DRAWING AMENDMENTS

REMARKS

-ig.2

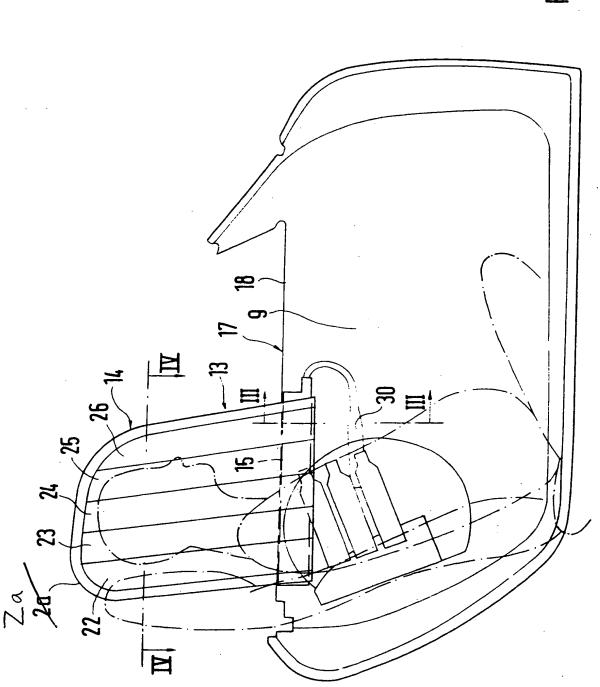
Please amend the drawings by substituting the replacement drawing sheet including Figure 2 appended to this Reply for the originally filed drawing sheet including that figure. An annotated sheet showing the change made on the replacement drawing sheet is also appended to this Reply.

The objections to the drawings set forth in sections 1 and 2 on page 2 of the Office Action are eliminated as a result of the specification and drawing amendments referred to above.
